Burlington Design Advisory Board

DESIGN ADVISORY BOARD Tuesday April 10th, 2018 at 3:00 PM Conference Room 12, City Hall, Burlington, VT Agenda

MEMORANDUM

To: The Design Advisory Board
From: Mary O'Neil, AICP, Principal Planner
RE: 298 College Street, ZP18-0834 CA/MA
Date: April 10, 2018

L-200

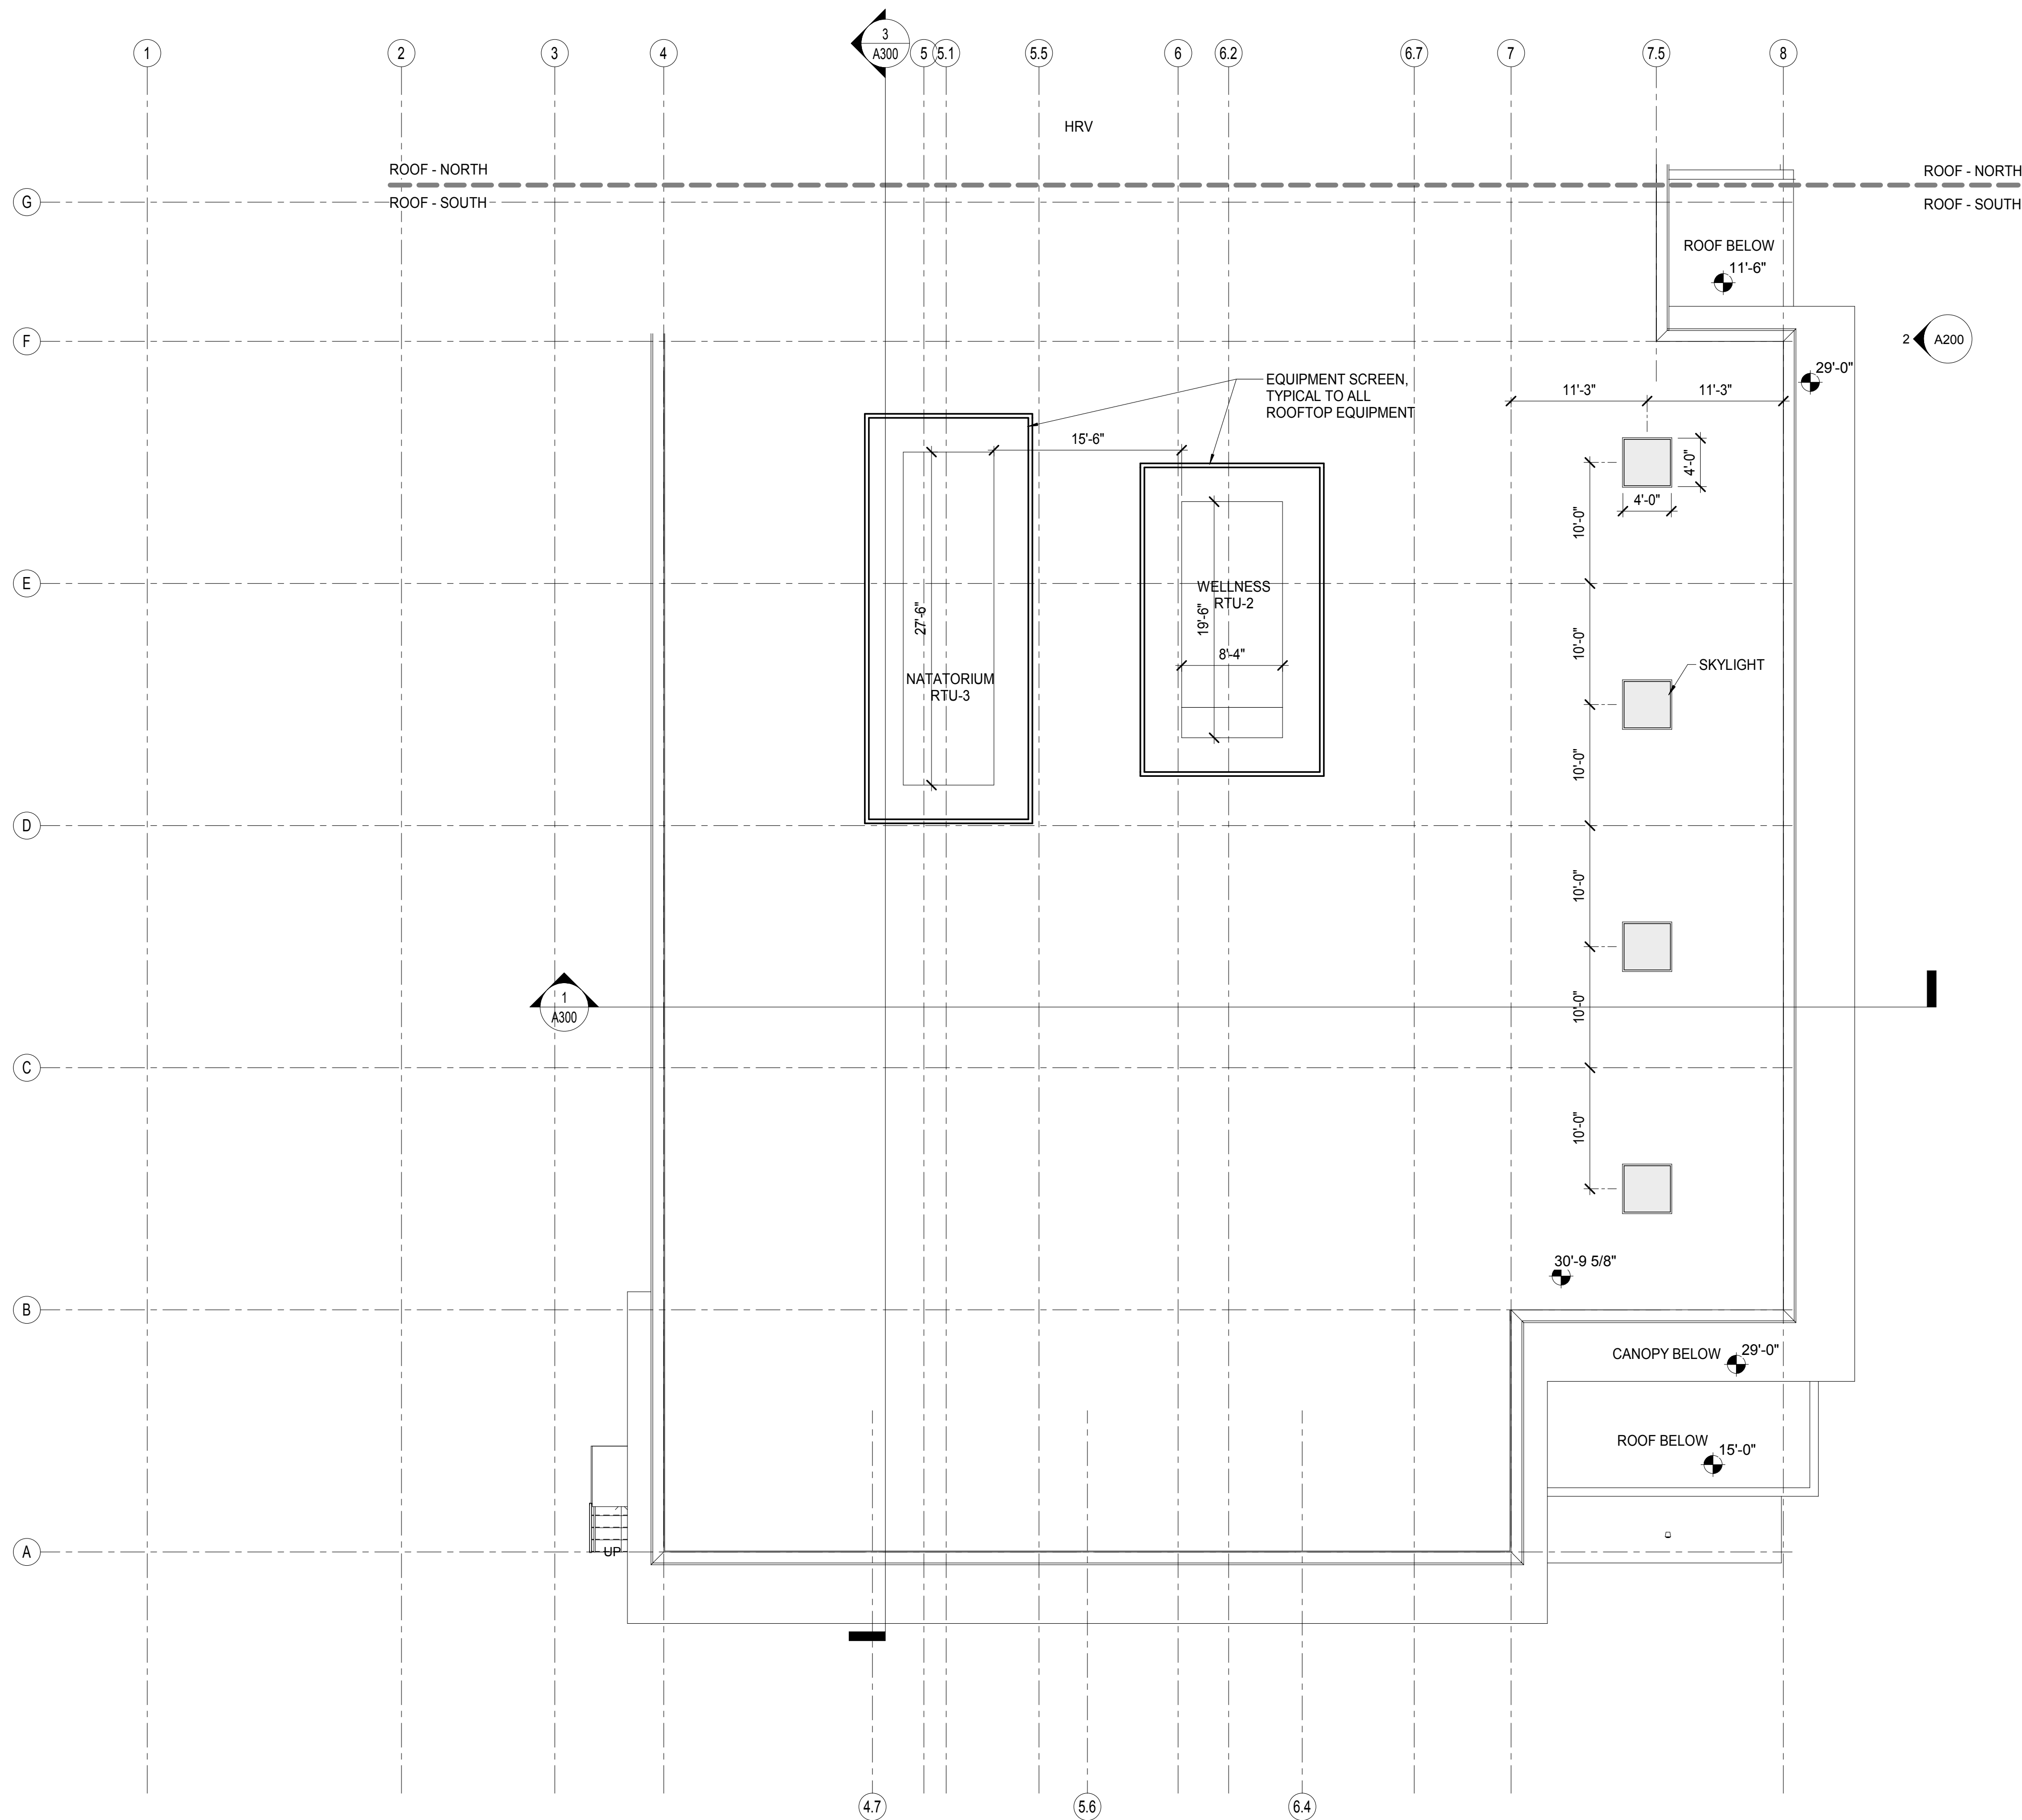
Application submission materials include specific lighting fixtures and a photometric plan. (See Plan L-200.) The design team notes that Vermont Building Code/NFPA 101 Life Safety requires an identified minimum lighting level along paths for the means of egress from building exits. (1 fc along walking surfaces, no less than 10fc at stairs.) A majority of the walkways on site are portions of the building's life safety exit discharge and are lit to meet these standards using full cut-off dimmable fixtures.

3. The design and materials of the trash enclosure has not been defined, and needs to be.
4. Illumination along walkways shall be adjusted so as to not exceed 2 fc, unless doing so would specifically conflict with NFPA Life Safety Code. A revised photometric shall be provided to demonstrate those changes.

A105

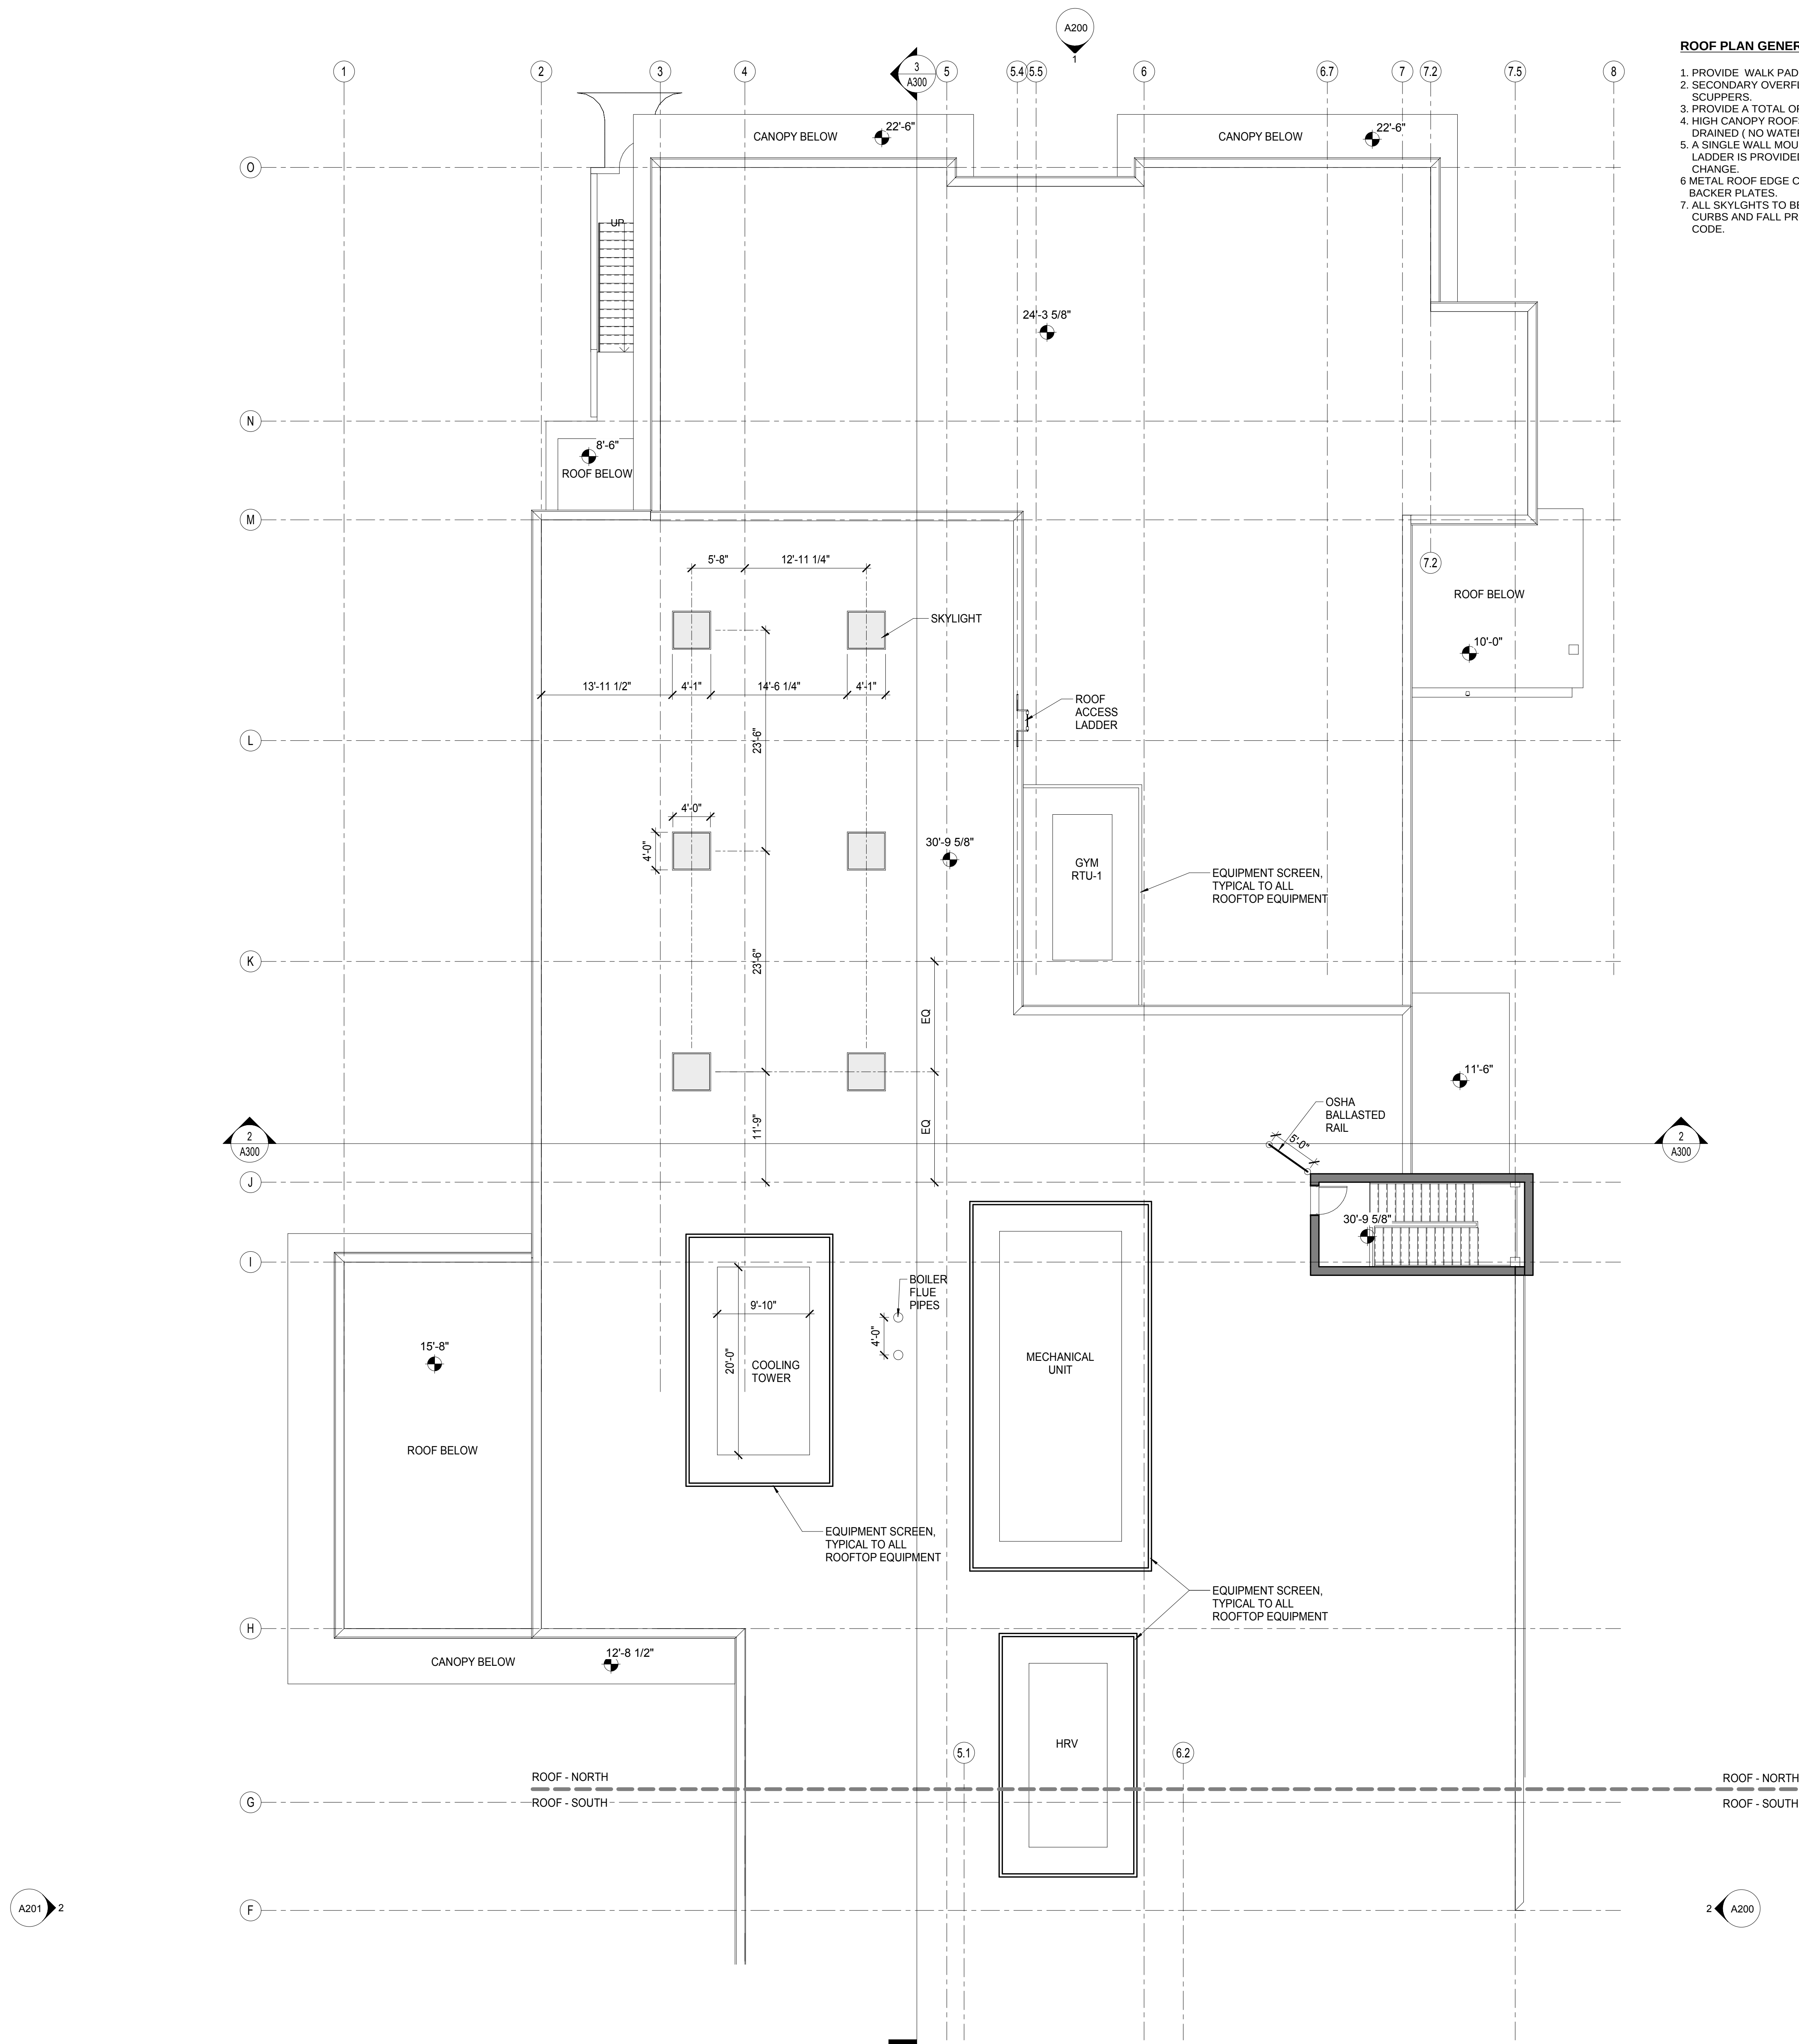
The roof plan identifies the location of proposed rooftop mechanicals; all which will be screened via the method identified above.
